5133 University Avenue
Addendum No. 1, Contract 9021
MUNIS 13464
Developer: Degen & Associates, LLC

To: Timothy Troester, P.E. (City of Madison)
From: Carley Jones, P.E. (JSD Professional Services, Inc.)
Re: 5133 University Avenue (Contract 9021) – Box Culvert Conflict
JSD Project #: 07-2912
Date: January 5, 2022
cc: Tom Degen, Justin Frahm (JSD), Mark Brusberg, P.E. (Steven's), Susan Lasecki, P.E. (Ionic)

5133 University Avenue – Private Sanitary / Box Culvert Conflict Meeting
12/20/21 @ 10:00 AM via Zoom

Figure A: Partial site plan showing location of sanitary line and existing box culvert.
Site plan provided by JSD Professional Services

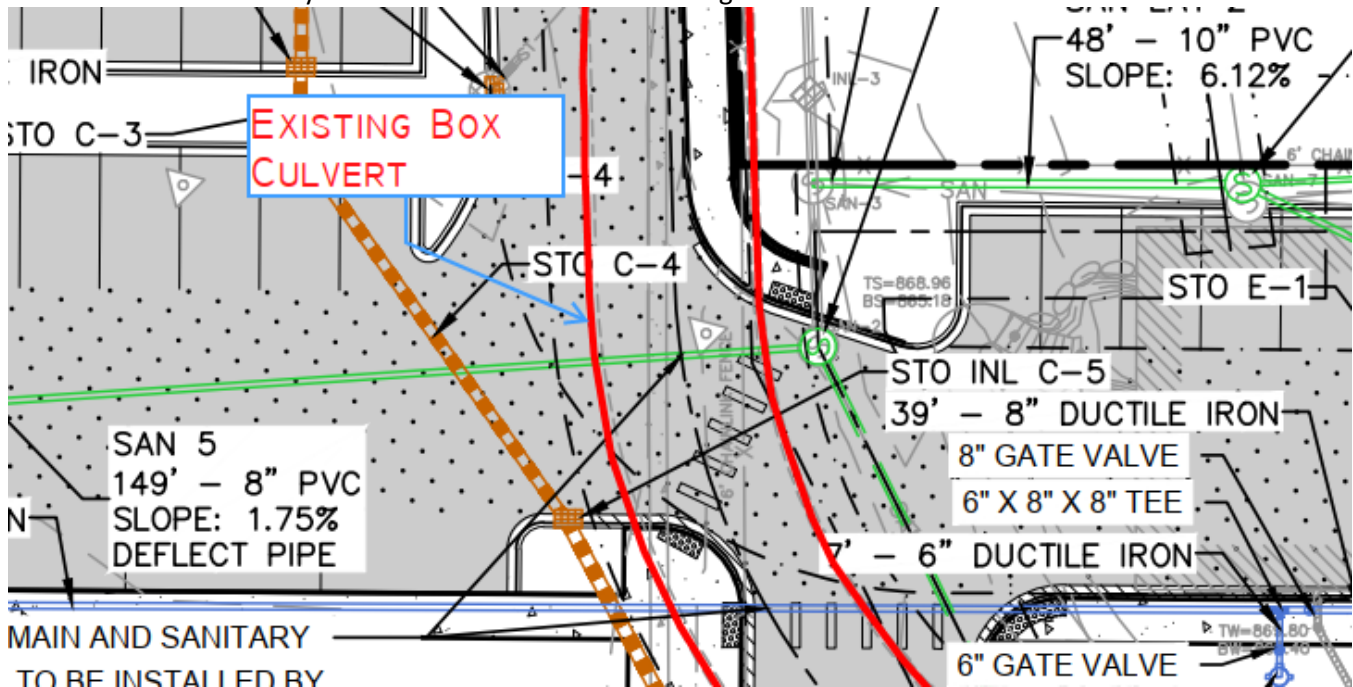
The proposed 8" sanitary line on the University Ave Apartment building project is to be installed beneath the existing box culvert. The elevation of the proposed sanitary line with respect to the existing box culvert based on the existing construction documents is not as anticipated.

The location of the sanitary line and box culvert are shown in Figure A.

The new sanitary line must be installed just below the box culvert which has changed the proposed method of installation. The design and construction team have worked together to determine the method of installing this sanitary line that will minimize the structural repairs needed to the culvert, create a safe working condition and minimize the amount of time that the culvert would be out of service. The design team and contractor propose the following approach:

- Saw cut and remove a portion of the existing precast concrete culvert lid.
- Sawcut and remove a portion of the base slab to within approximately one foot of the existing culvert walls.
- Excavate and remove the soil within the area of the sanitary line as needed for the installation of the pipe.
- Install the sanitary line.
- Fill in the remaining excavated area with controlled low strength material (CLSM concrete fill).
- Drill and dowel bars into the existing base slab along the perimeter of the opening.
- Place reinforcement in infill area.
- Place bentonite (or equivalent) waterstop at joint between the infill area and the existing concrete slab.
- Cast new concrete in infill area.
- Reinstall precast cap and anchor to existing walls with a mortar bed and drilled and epoxied dowels.

Figure B: Proposed partial demolition of existing box culvert.

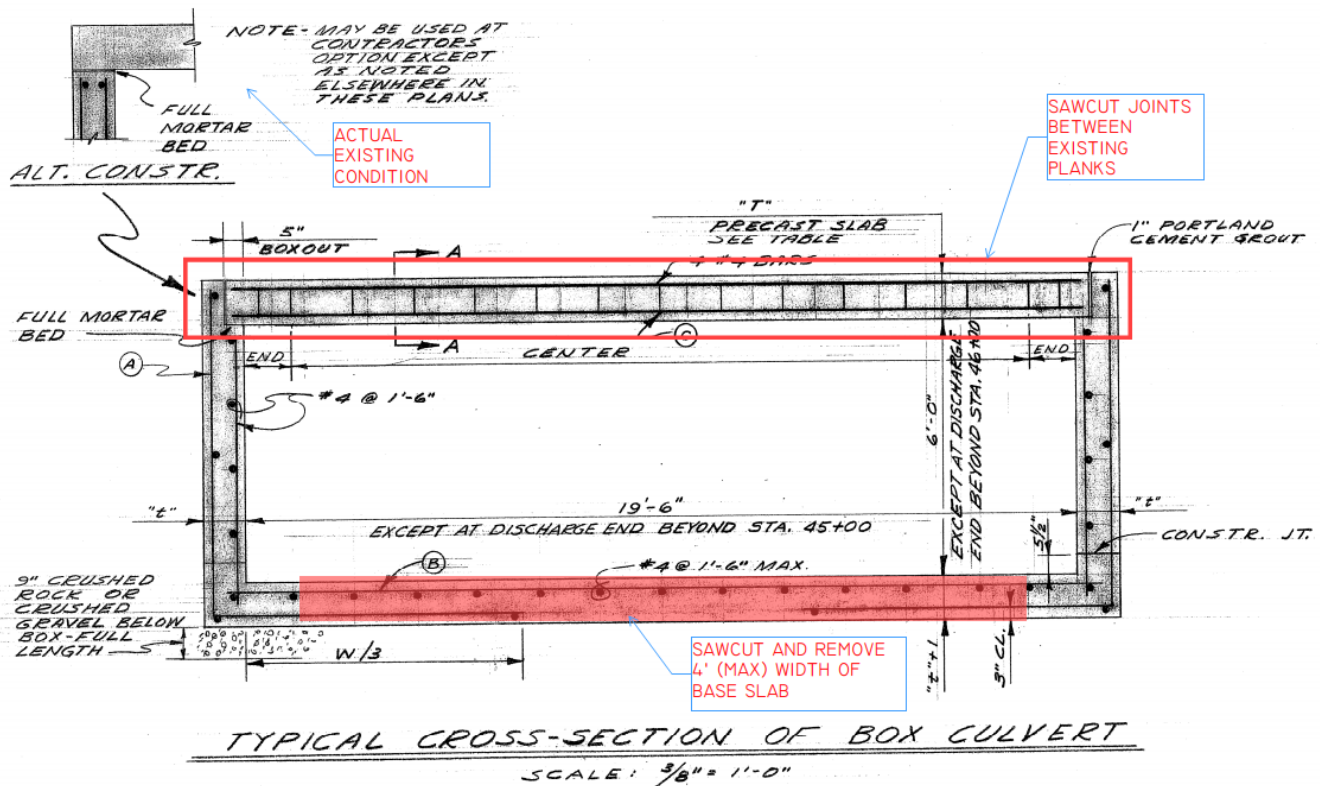
A section illustrating the proposed approach has been provided in Figure B, below. This section is taken from the original construction documents as prepared by Mead and Hunt, dated October 1963.

This approach should limit the extent of demolition needed to install the sanitary line and limit the amount of time the culvert is unable to be in service.

ATTACHMENT 2 – PLAN MARKUP

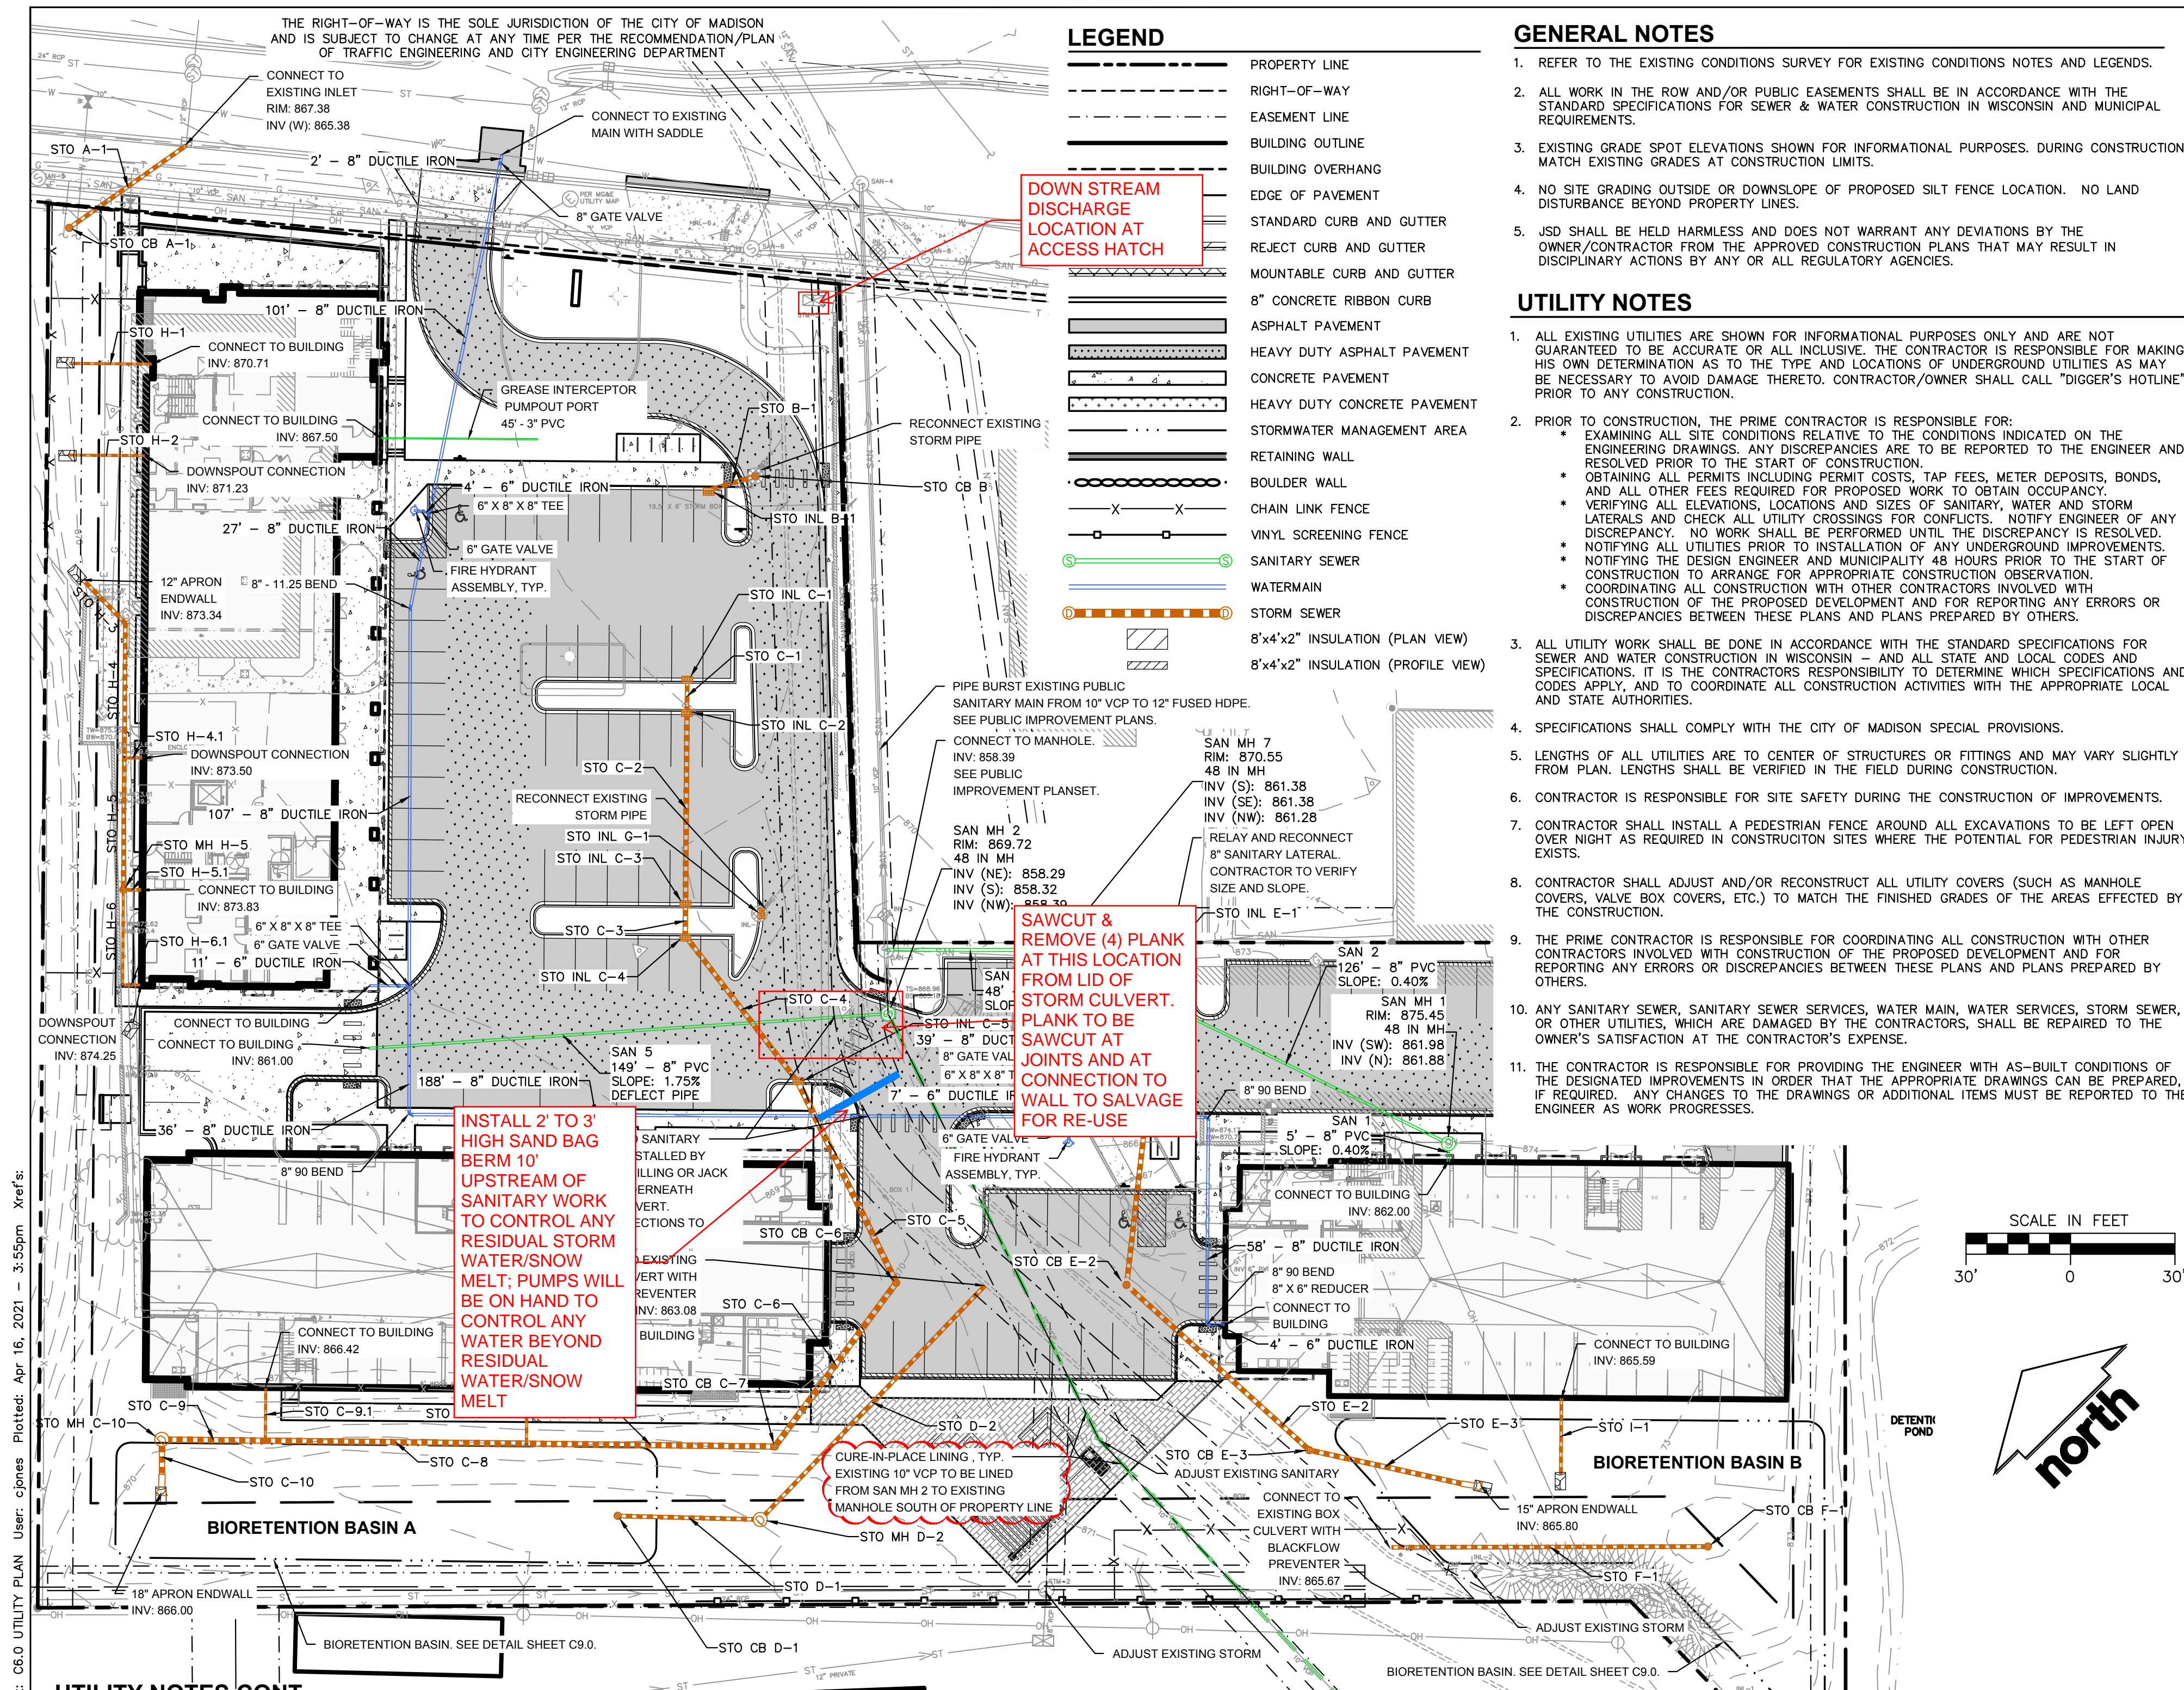
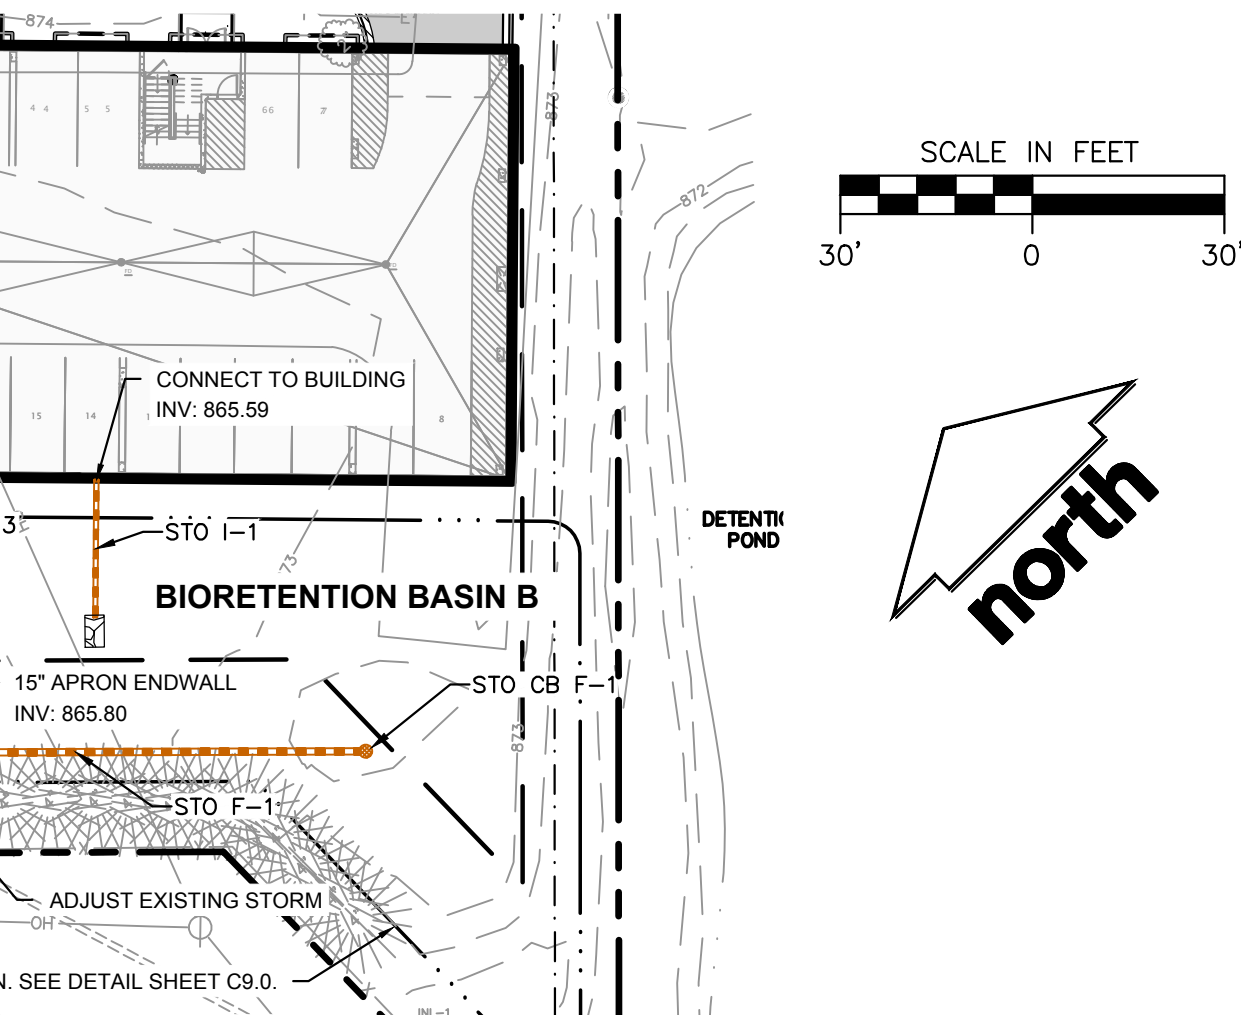
As stated in the email from 12/20/2021 from Tim Troester (Attachment 8), this memo is to serve as the “memo or letter from the Developer or Developer’s Engineer on what their preferred option is.” The construction team and owner prefer and have decided to move forward with OPTION 1; which includes removal of a section of the box culvert, installation of the sanitary lateral at a slope of 0.4% along original proposed alignment, and the replacement of a section of the box culvert. This option will install the proposed sanitary lateral as originally indicated on the city-approved plans. See attachments for detail of the removal and replacement of the box culvert.

ATTACHMENT 3 – BOX CULVERT CROSS SECTION – REMOVAL AND
REPLACEMENT

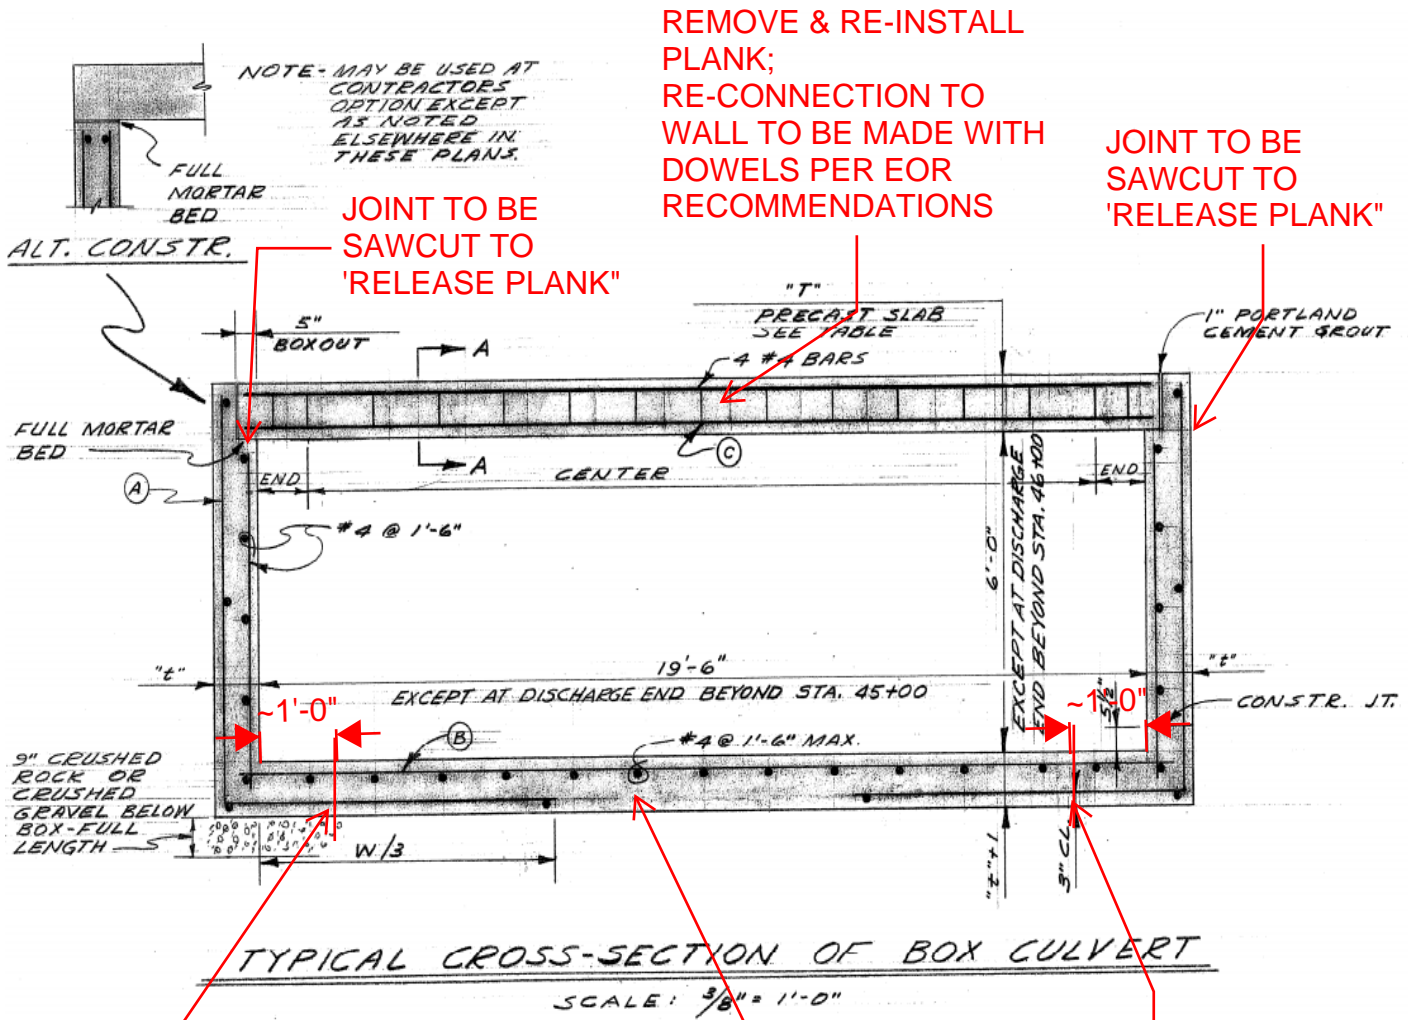
SAWCUT CULVERT "MAT" SLAB FOOTING AT ~1'-0" IN FROM WALL

SAWCUT CULVERT "MAT" SLAB FOOTING AT ~1'-0" IN FROM WALL

REMOVAL:
SAW CUT AND REMOVE "MAT" SLAB; REMOVAL SECTION TO BE ~4'-0" WIDE BY ~17'-6" IN LENGTH ACROSS THE CULVERT;
REPLACEMENT:
DRILL & DOWEL REBAR; INSTALL BENTONITE WATERSTOP, INSTALL REBAR TO REPLACE IN KIND OF EXISTING; POUR BACK WITH 4000PSI CONCRETE WITH ZYPEX ADDITIVE

ATTACHMENT 5 – BOX CULVERT CROSS SECTION – VERTICAL
CLEARANCE

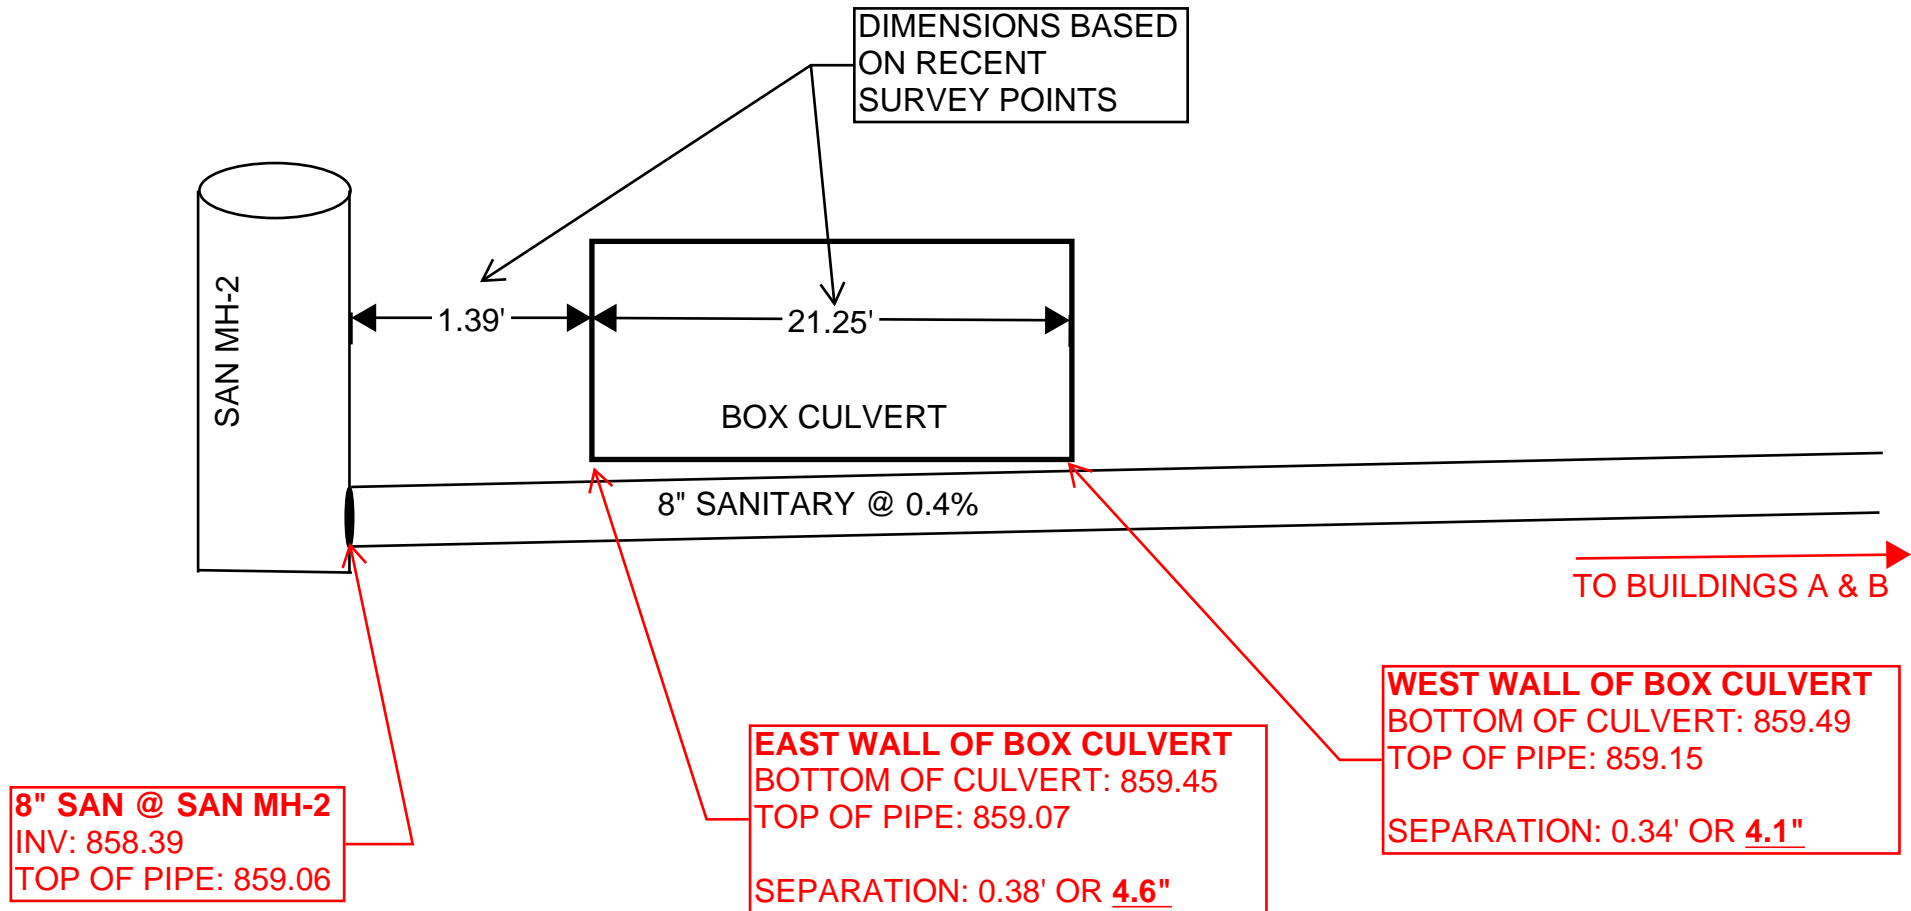
- Vertical elevation clearance originally assumed at ~12"; field survey verified at ~4" with both sides of the storm box culvert excavated;
- Based on limited clearance, City approved contractor is unable to execute original means and methods to allow for jack and bore of new private sanitary lateral under storm box culvert
- Will require open cut and replacement of portion of existing box culvert

Issue – only 4” to 6” clearance between top of proposed private sanitary lateral pipe and the bottom of the existing box culvert – with these conditions not able to directional drill / jack & bore as originally planned for constructing the private sanitary lateral connection.
